CONSERVATION TEAM CONSULTATION APPLICATION RESPONSE

APPLICATION REF:	25/02515/LBC & 25/02596/FPH
CASE OFFICER:	VW
APPLICATION SITE:	Old Manor House, Shaftenhoe End, Bogmoor Road Barley, Royston, Hertfordshire SG8 8LE
DESCRIPTION OF WORKS:	Extend south gable end, change cladding, and alter fenestration of existing west extension. Internal and external alterations including installation of air source heat pump on west elevation of existing west extension.

Figure 4.50: Showing the phasing of the house. The following key has been used:

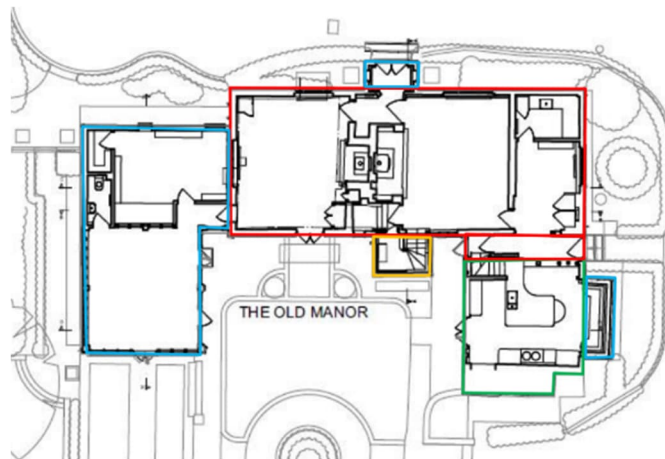
Section 4.0 entitled 'Background Understanding of Site – Site Inspection' on page 44 of the submitted Heritage Statement provides a chronology for this building which assists the understanding of this heritage asset.

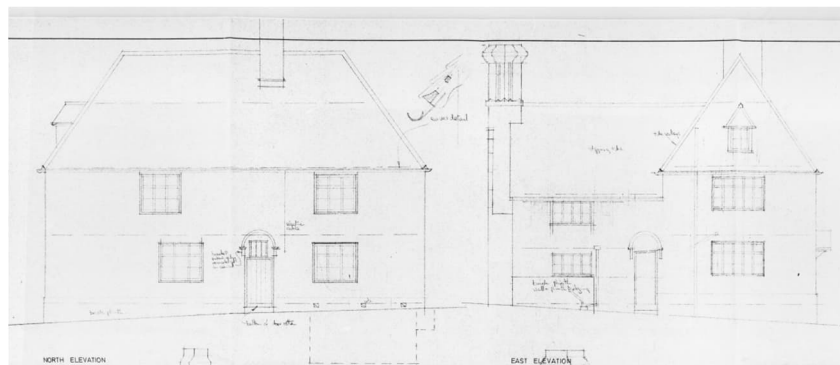
These windows appear to be the very same windows depicted in the existing elevation drawing no. 218/3 submitted under ref: 92/00169/1LB

According to one source the tripartite sash window, specifically featuring the vertically sliding mechanism, gained prominence in 18th-century Britain as part of the Palladian and Georgian architectural movements. This building is neither Georgian or Palladian but a sense of grandiosement was created following the granting of consent under ref: 92/00169/1LB including dormers and large tripartite sashes (6-over-6s flanked by either 2-over-2s or 4-over-4s). Whilst SPAB considered that these windows would spoil the building's attractive simplicity, the significant attention paid to their detailing as noted in submitted drawing no. 218/8 is such that I consider that they make a positive contribution. I also note page 45 of the current HS which says that "prior to their installation the building had casement windows, more in keeping with the style of the building". Introducing slimlite-glazed mullion/transom windows is considered acceptable subject to the glazing bars not being applied.

Figure 4.14: 1992-94 photograph showing the historic splat balusters and newel post in the stair wing (Source: Historic England Archives, Reference: BBS2/06134).

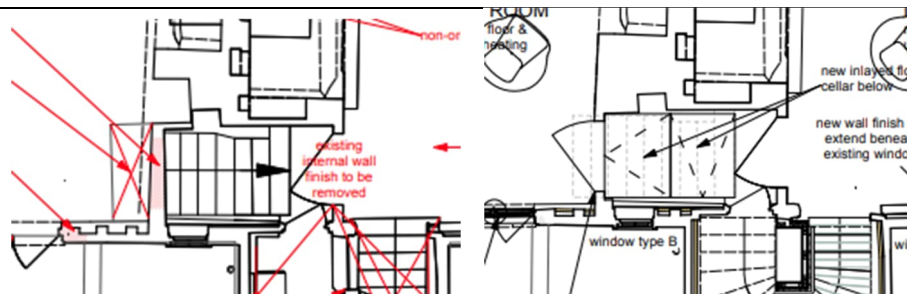
The current staircase newel post and splat balusters do not accurately copy the historic example seen in the 1992 photograph at Figure 4.14. The present balusters and newel post are mediocre in the quality of their execution.

Whilst it would be disappointing to see the replacement of the splat balusters with a sandblasted and blackened steel purpose-made balustrade, there is no convincing justification to resist this in heritage terms.

Figure 4.134:
Showing the doorway from the western bedroom into the bathroom at first floor level within the sun room.

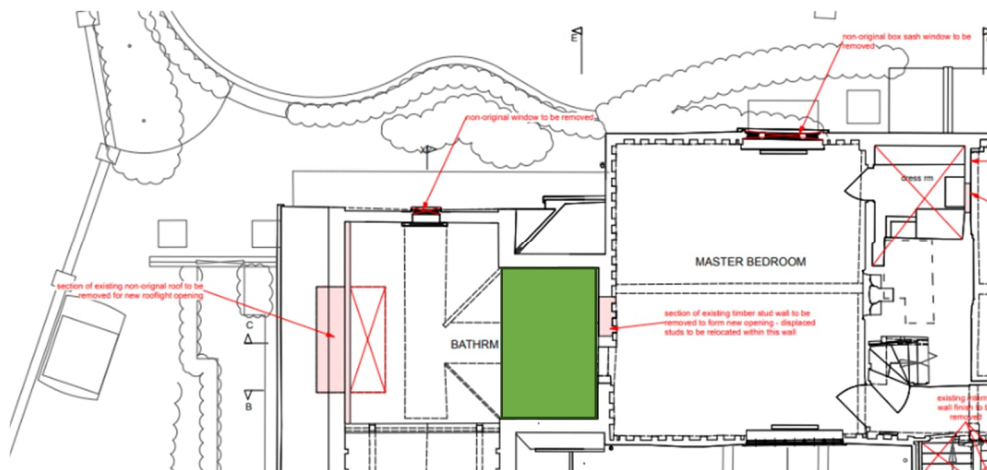
Although the door has no significance, there appears to be no convincing justification for moving the door position and which will result in the unnecessary loss of historic fabric forming the gable end. I understand the rationale for introducing a full height naturally lit space over the kitchen but I encourage a compromise whereby a smaller Master ensuite is provided in the area shaded green below instead of there being a landing to the Master Bedroom. By all means introduce the circular shower into this space.

Figure 4.150: Showing the western wall of the north-eastern bedroom.

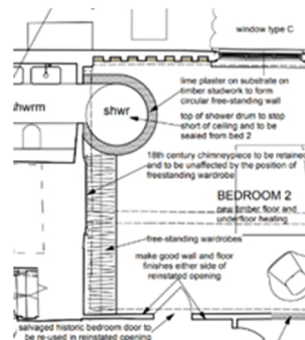
The earlier image below left (from DAS) can be compared with fig 4.150 at page 73 of the HS (below right).

Drawing no. 580 02 03 - Proposed 1st Floor Plan, shows the proposed shower to Master Bedroom penetrating Bedroom 2's space and the fireplace covered by wardrobes.

Generally speaking, whilst some alterations may be reversible, the shower would be a semi-permanent incursion into Bedroom 2's space at the very least. I agree that there would be a degree of harm to the building's significance but this is not at the negligible end of the 'less than substantial' spectrum as suggested. When considered also alongside the screening of the bolection moulded chimneypiece and overmantel I conclude that the degree of harm to this room would be low/moderate. Considering that the existing

bathroom to the Master Bedroom is within the later addition, the shower room appears to be somewhat unjustified and adversely affects Bedroom 2's internal character. The same can be said of the wardrobes in Bedroom 2.
